City of Sanibel

**ADDENDUM NO. 5
April 30, 2026**

RE: Sanibel Slough Hydraulic Dredging Project (ITB-NR-1-2026/BS) Proposal due date: May 07, 2026 @ 2:30PM

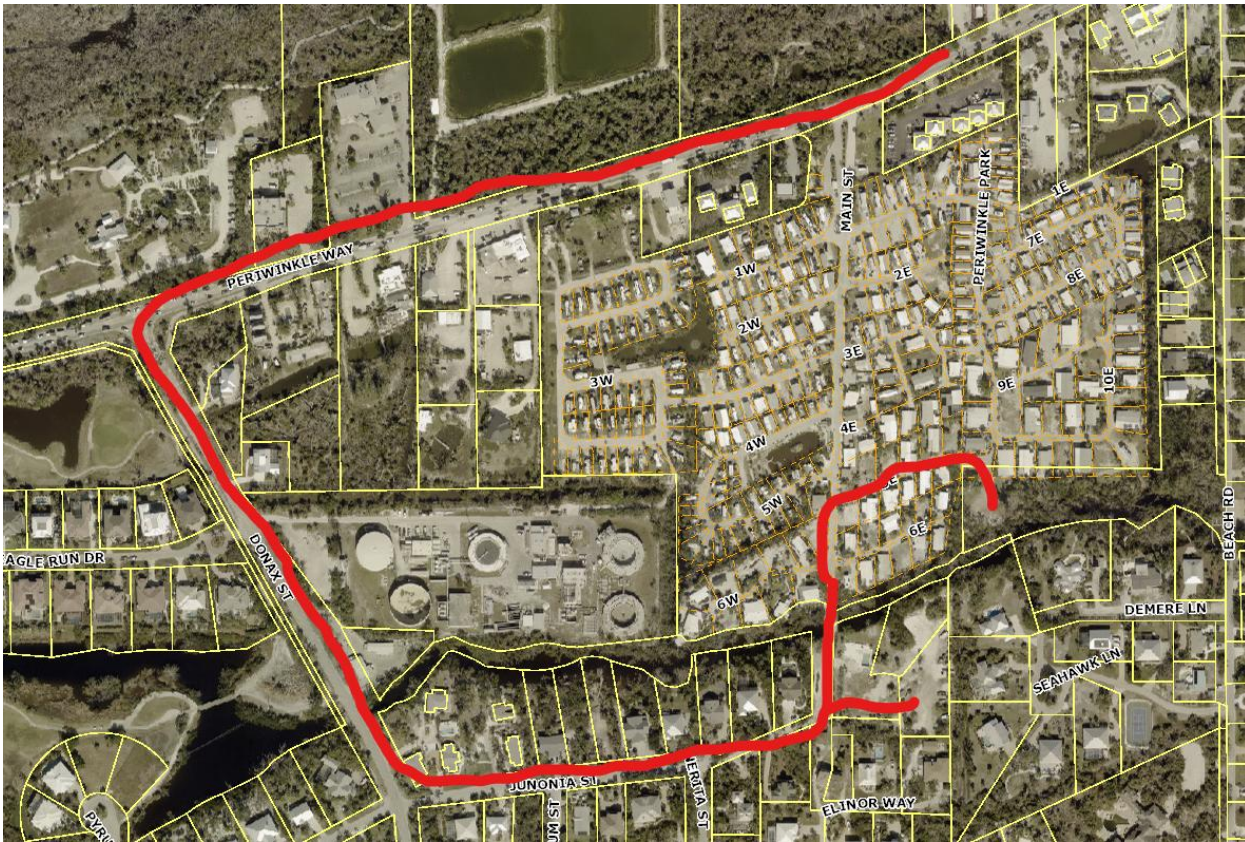
Question No.7: Can the city share the anticipated truck route through the campground?

Response No.7: The best route of access is Periwinkle Way to Donax Street to Junonia Street. See map below.
